Interactive comment on “Impact of LUCC on Streamflow using the SWAT Model over the Wei River Basin on the Loess Plateau of China” by Hong Wang and Fubao Sun

Subject: Revise the manuscript (#hess-2016-332)

The Title: Impact of LUCC on Streamflow Based on the SWAT Model over the Wei River Basin on the Loess Plateau of China

Fig. 1. Fig. 1 The development of soil and water conservation measures in the main stream basin of Wei River over last 50 years.

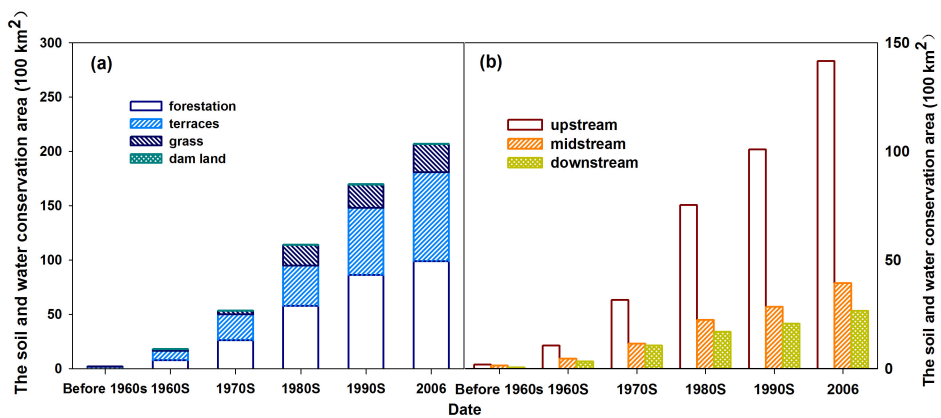
1: First of all, I am questioning the significance of the hydrological changes that actually occurred in the catchment over the studied period. Although figure 1 indicates that forested areas increased by about 65.104 hm² (unusual unit used on the Y axis), which is equivalent to 14% of the upper catchment area, figure 3 inconsistently shows that forested area increased by only 0.81% (line 137) over the same period (1980 to 2005). How to explain this difference? If we rely on figure 2 (which is likely the most reliable source), we can expect minor influence of forestation on the basin hydrology.

(34) Fig. 1: Areas under different treatments are expressed in 104 hm² (i.e. squared hectometers?). This is an atypical unit which is different from the unit used for the study area in the text (104 km²). All areas should be provided in same unit to allow easier comparison. It would be clearer to provide the percentage area so that we anticipate the possible effect of the land treatment on the catchment hydrology.

Thank you for pointing this out, which makes us think it through. In fact, these two datasets are from different sources. First of all the number in Fig. 1 is for 6.53% (instead of 14%) as shown in detailed explanation below, which is still higher than 0.81% as pointed by the referee. This is a classic issue in the national survey on soil and water conservation where they only take the revegetation implemented into account and ignore for example possible death of vegetation, which is important in the land use map. One more thing is that the national survey when counting the revegetation areas does not consider the vegetation coverage, which is in fact important in any hydrological modelling including the SWAT modelling. We agree with the referee on that point. With that caution, however, Figure 1 is just for a reference on the development of the soil and water conservation project in China. The data we are relying on are the land use maps. Detailed explanation below:

(1) There are some detailed descriptions about Fig.1. The same legends for Fig.1 (a) and (b) brought some confusion, so we revised the legends of Fig. 1. Figure 1 is the developing process of the soil and water conservation measures in the main stream basin of Wei River, including the upper and middle reaches (4.68×10^4 km²) and the

downstream of the main stream ($1.65 \times 10^4 \text{ km}^2$). Figure 1 involves about $6.33 \times 10^4 \text{ km}^2$. Figure 1 (a) is the area developing of forestation, terraces, grass and dam land separately. The area of forestation was about $57.43 \times 10^4 \text{ hm}^2$ during 1980s and it increased to $98.75 \times 10^4 \text{ km}^2$ in 2006, which equivalent to 6.53% of the main stream basin of Wei River. And Fig. 1 (b) is the sum area of the forestation, terraces, grass and dam land in upstream, midstream and downstream. And the sum area increased by about $66.15 \times 10^4 \text{ hm}^2$ in upstream.

(2) Figure 1 is the statistical data of government based on natural forest before and artificial planting area, which involves all planting of forestation without considering canopy density, surviving or deforestation and so on. The forest of the LUCC data refers to the natural forest and plantation, which canopy density is larger than 30% (Table 3: note 1).

(3) The forest data of Fig. 1 also includes planting land used as agro-fruit, agro-mulberry, agroforestry and replanting land for trees. While land used for agro-fruit, agro-mulberry, agroforestry is classed as Agricultural land (Table 3: note 2) in LUCC.

(4) There are also some screening conditions for land use types dividing in SWAT model. For hydrological response unit (HRU) analyst, the Dominant Land Use method was used for HRU definition. So the dominant unique combination of land use in the subbasin is used to simulate the HRU. Figure 1 shows the area of grass is smaller than forest's, while it is opposite in LUCC and SWAT model attributed to canopy density and the Dominant method.

Thank you for your suggestion. Figure 1 is revised as suggestion.

Fig. 2. Fig. 8 The time-series graphs of calculated vs. observed streamflow during 1980-2009 for hydrological stations.

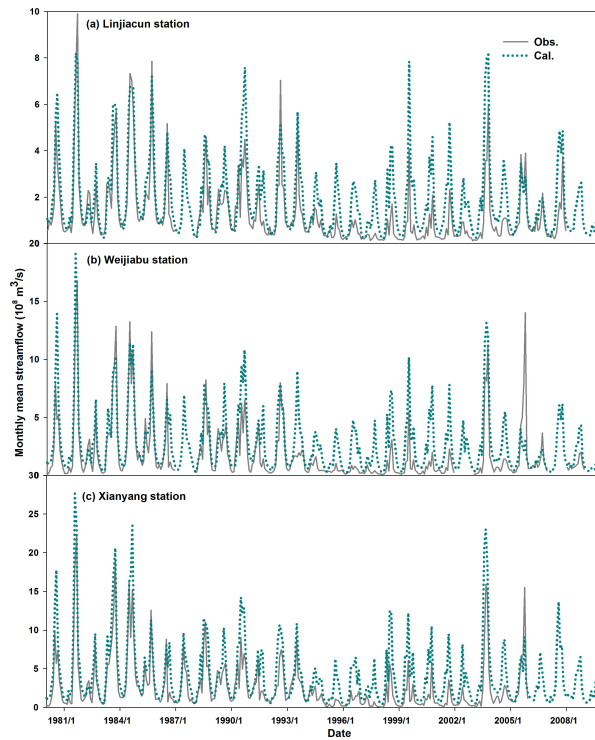
(1) The main issue of this paper is that all the demonstration relies on simulated flows only. Flow simulated over the period 1980-2009 with land-use from 1980 should be compared to actual flow recorded over the period 1980-2009.

Thank you for your comments. We add a new Fig. 8 to show the time-series graph of calculated streamflow vs. observed streamflow during 1980-2009 for hydrological stations. We can see the calculated streamflow matched well with the observed values during 1980s. The observed values were measured daily based on the actual LUCC, while the calculated streamflow was got based on LUCC of 1980. So Fig. 8 shows the calibrated SWAT model played well in our study area and the changing LUCC can affect streamflow gradually. The streamflow of typical year, the same year with LUCC, is the results of by LUCC and meteorological conditions. To reduce influence of meteorological condition and isolate the impact of the LUCC on streamflow, 30-year average of the streamflow for forest and agricultural land were taken, respectively. For period of 1980-2009, we just used their measured and long-term daily meteorological data in the study area to drive the validated model for the designed hydrological experiments.

Fig. 3. Fig. 6 The time-series of precipitation, annual streamflow and runoff coefficients for the study area

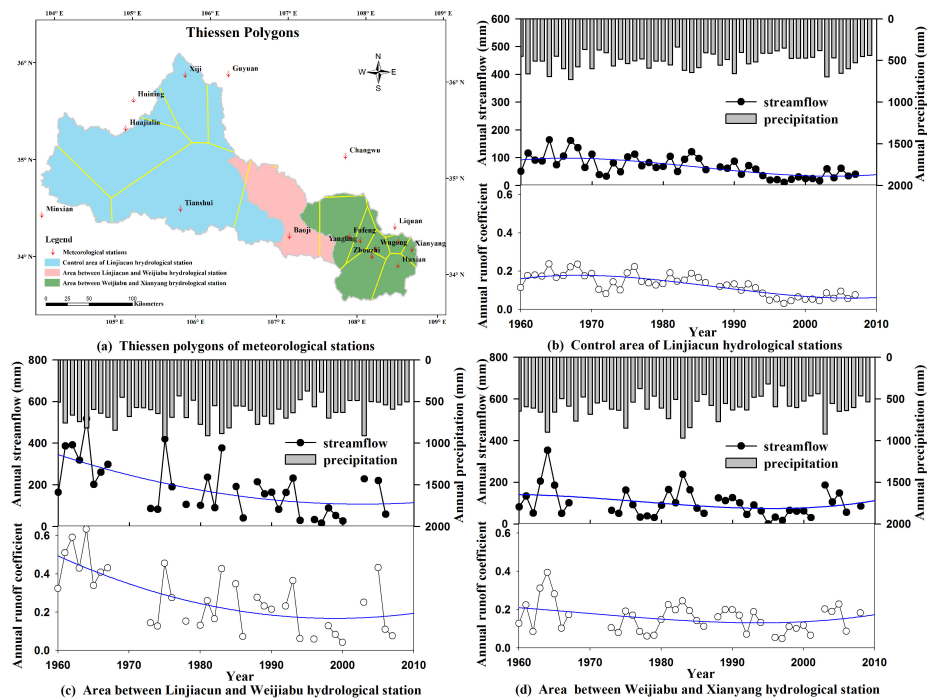
(2) Another issue is the implicitly presumed stability of the catchment behaviour over each of the 2 periods 1960-79 and 1980-2009. A graphic showing annual flow, rainfall (both in mm) and runoff coefficients in each of the 3 nested catchments and intermediary catchments (e.g. the colored areas in figure 2) would provide a first assessment of the possible effects of the land-use changes (as done in Lacombe et al. (2008)). A statistical assessment quantifying change and/or trend significance is also missing (cf. Lacombe et al. (2016) for an example).

(8) Line 90: This statement should be supported by a figure showing the time series of actual annual flow (cf. main comments).

Thank you for your comments. For period of 1980-2009, we just used their measured and long-term daily meteorological data of the study area to drive the validated model. There was only one variable (LUCC or vegetation) to analyze its impacts on streamflow quantitatively. So the soil data, DEM and meteorological data are all same. The figures of annual flow, rainfall and runoff coefficients for 3 regions of Fig. 2 in the study area are added as Fig. 6. The annual average precipitation over the region was calculated using Thiessen polygon method of ArcGIS 9.3, which divided the basin and gave the

weight of each meteorological station according to its control area (Fig. 6 (a)). And the regional annual average runoff coefficients were 0.13, 0.27 and 0.16 for figure 6 (a), (b) and (c) in turn.

Thank you for your suggestion. The figure of actual annual flow has been added (Fig.6).

Fig. 4. Fig. 1.1 The monthly time-series graphs of calculated vs. observed values during calibration period and verification period for hydrological stations

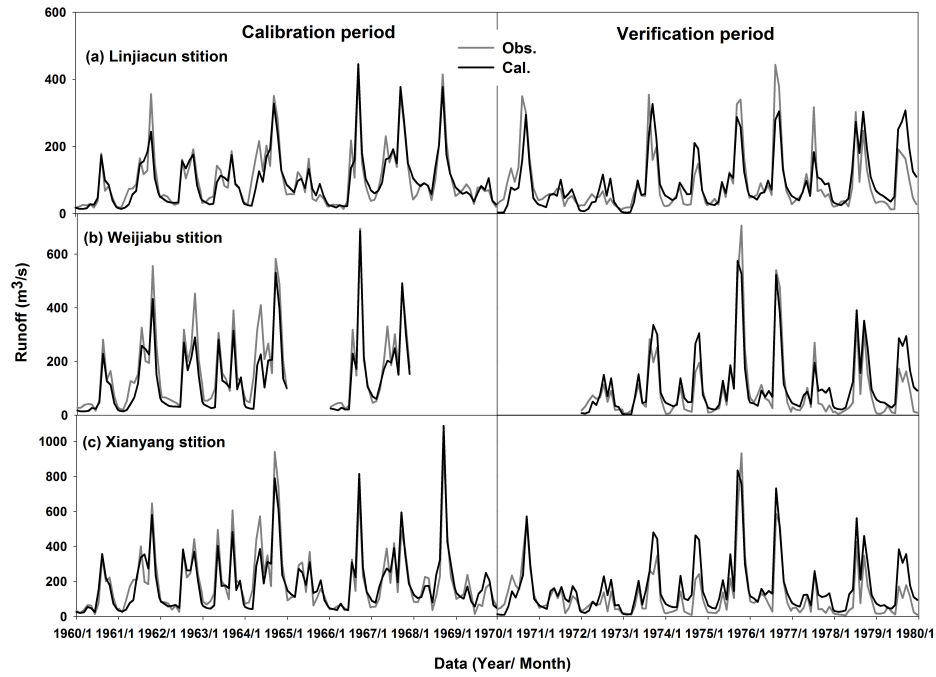
(27) Lines 257, 258: unlike what is written, the trend is not obvious in fig. 6. It would be clearer to redraw the figure at the monthly and annual time steps to visualize possible trends over years.

Thank you for your suggestion. The monthly time-series graph of calculated vs. observed values during calibration period and verification period for hydrological stations is as follows.

Fig. 5. Fig. 7 The time-series graphs of calculated vs. observed values during calibration period and verification period for hydrological stations.

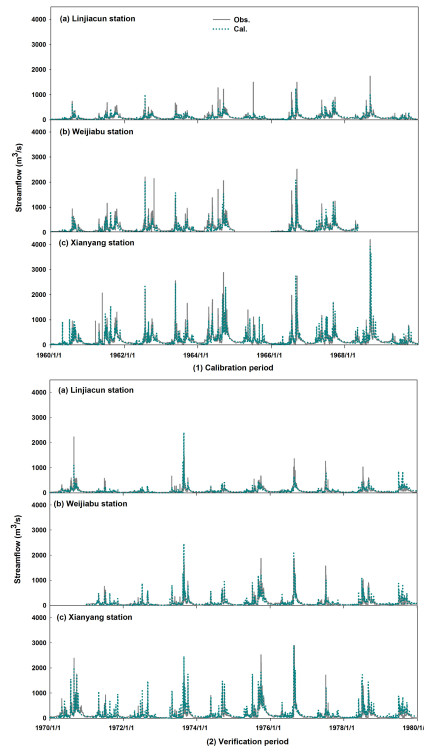
(36) Fig. 6. The scale on the X axis is too big: we cannot see the details in the daily flow variations and in the matching between observed and simulated flow. The figure should be bigger or all panels (calibration and verification should be put in the same column to allow larger size.

Thank you for your suggestion. It is more clearly indeed as suggestion (Fig. 7).

Fig. 6. Fig. 11 The corresponding proportional change rate of streamflow at Linjiacun, Weijiabu and Xianyang station for annual average and annual average in non-flood season.

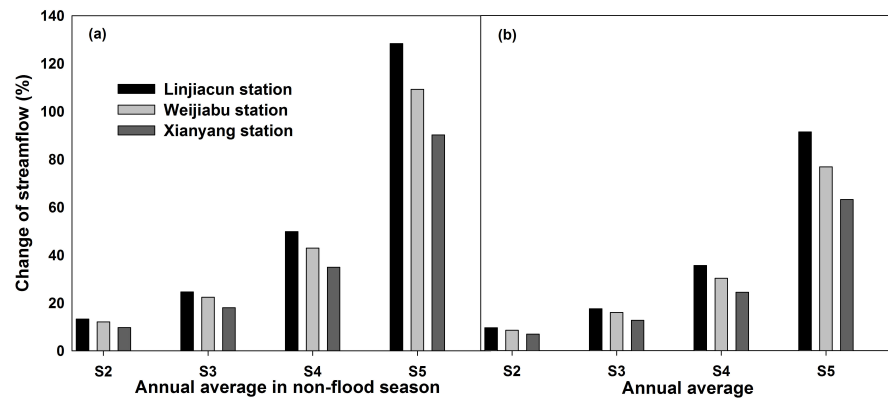
(37) Fig. 9: What is the meaning of "corresponding proportional change rate"?

Thank you for your suggestion. It is the change rate of streamflow at the Linjiacun, Weijiabu and Xianyang stations correspondingly. We have revised the figure (Fig.11).
